# CITY OF ALBUQUERQUE

RE: **Lot 29 Block 8 Unit 22 Volcano Cliffs SAD 228**  
**6401 Picardia NW**  
**Grading and Drainage Plan**  
**Engineers Stamp Date 1/19/17 (D10D003E29)**

## DRAINAGE AND TRANSPORTATION INFORMATION SHEET (REV 09/2015)

**Subject:** FW: 6401 Picardia

ENGINEER'S SEAL  1/19/17 DAVID SOULE P.E. #14522	LOT 29, BLOCK 8, UNIT 22 VOLCANO CLIFFS	DRAWN BY JDG
	GRADING AND DRAINAGE PLAN	DATE 01-15-2017
 Rio Grande Engineering 1606 CENTRAL AVENUE SE SUITE 201 ALBUQUERQUE, NM 87106 (505) 872-0999		SHEET # 1 OF 1
		JOB #

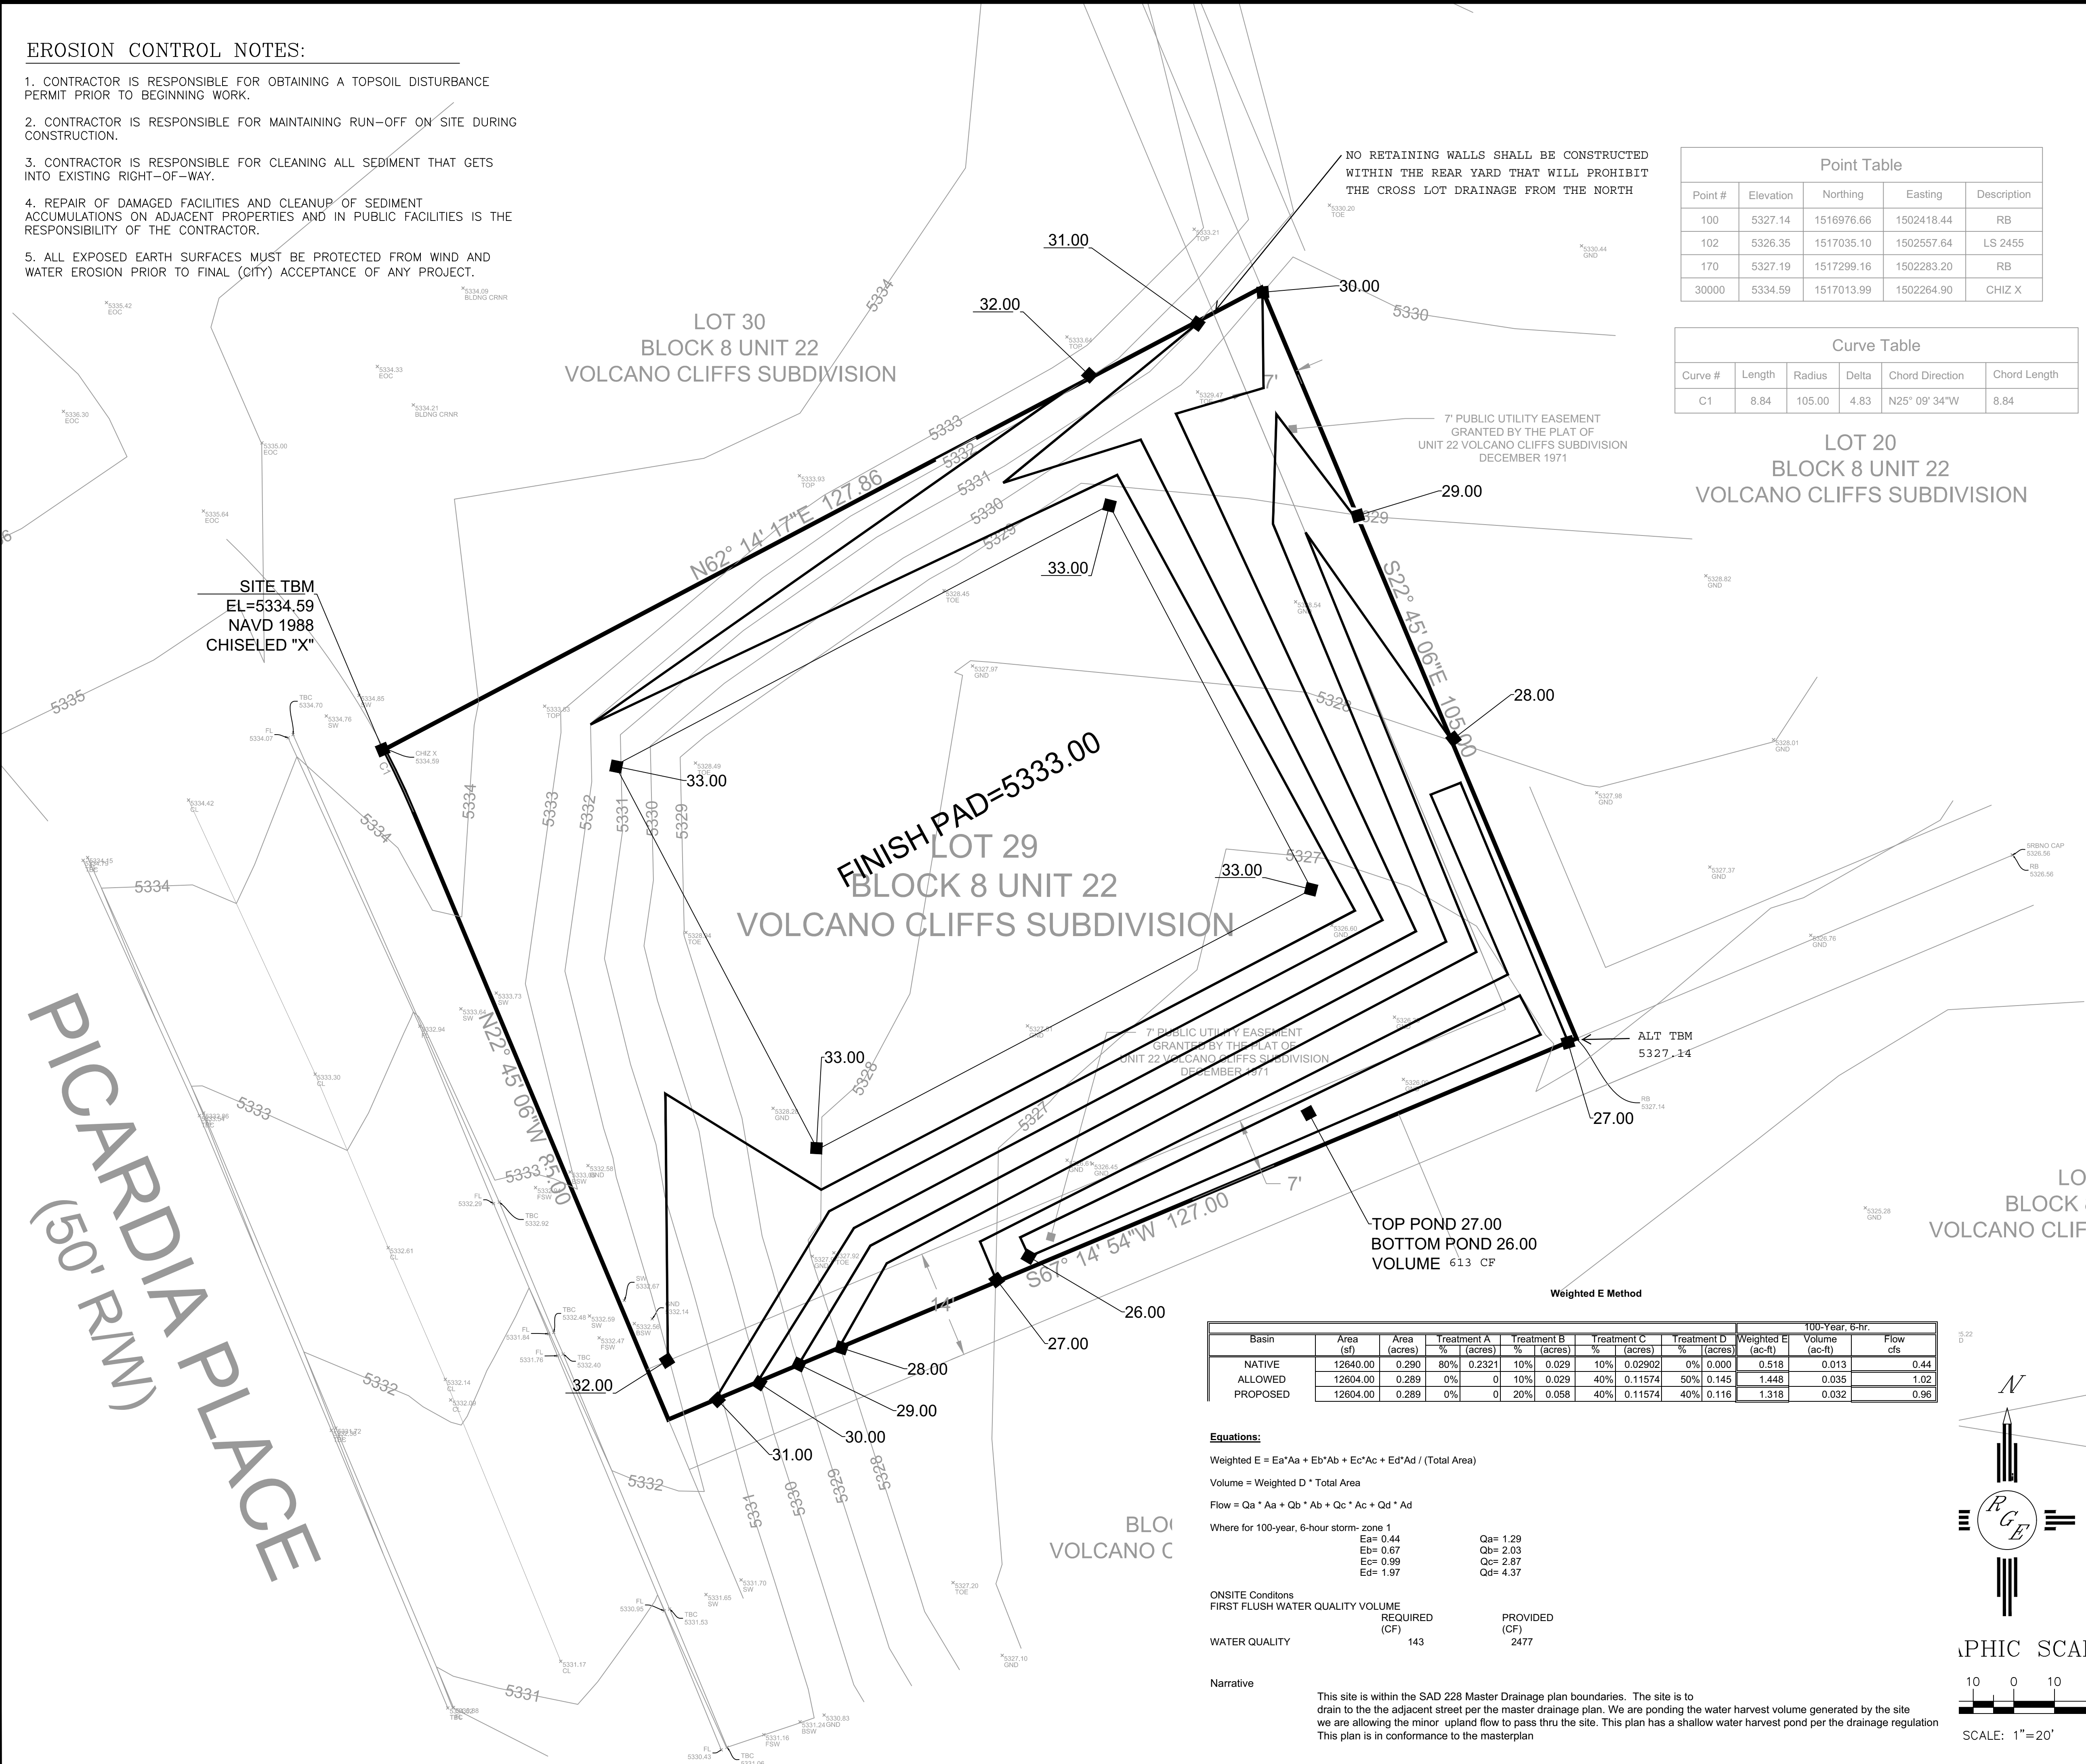
Based upon the information provided in your submittal received 1/17/17, the above referenced Grading and Drainage plan dated 1/16/17

cannot be approved for Grading Permit until the following comments are addressed:

- Provide a note stating that future garden walls require a separate permit and this plan should be used for their placement. [We have added note](#)
- Also state that future garden walls require an opening 3" above grade in the NW corner and SW corner. [We have added note](#)
- Provide a note stating retaining walls are not allowed in the rear yard unless a swale is provided so flows may pass from the property to the north into their property and to the south property. [We have added note](#)
- Provide a statement that a pad certification is required before a building permit is given. [We have added note](#)

1. ALL SPOT ELEVATIONS REPRESENT FLOWLINE ELEVATION UNLESS OTHERWISE NOTED.
2. TOPOGRAPHIC SURVEY INFORMATION SHOWN ON THIS PLAN WAS OBTAINED BY CONSTRUCTION SURVEY TECHNOLOGIES, INC PLS 21082
- 3.. ALL DISTURBED AREAS MUST BE RESEED OR LANDSCAPED PRIOR TO FINAL C.O..
4. ALL AREAS OUTSIDE THE BUILDING ENVELOPE MUST BE RESEED WITH NATIVE MIX
4. DUE TO EXISTING TOPOGRAPHY AND UNDEVELOPED NATURE OF THE DOWN STEAM AREA, PERIODIC MAINTENANCE OF PONDS AND SWALES ARE REQUIRED.
- 5.ANY FUTURE WALLS MUST BE PERMITTED BY THE CITY OF ALBUQUERQUE.
- ALL WALLS SHALL BE CONSTRUCTED TO ALLOW FOR CROSS LOT DRAINAGE BY TURNING BLOCKS 3" ABOVE FINISHED GRADE
6. PAD CERTIFICATION BY ENGINEER IS REQUIRED PRIOR TO BUILDING PERMIT RELEASE
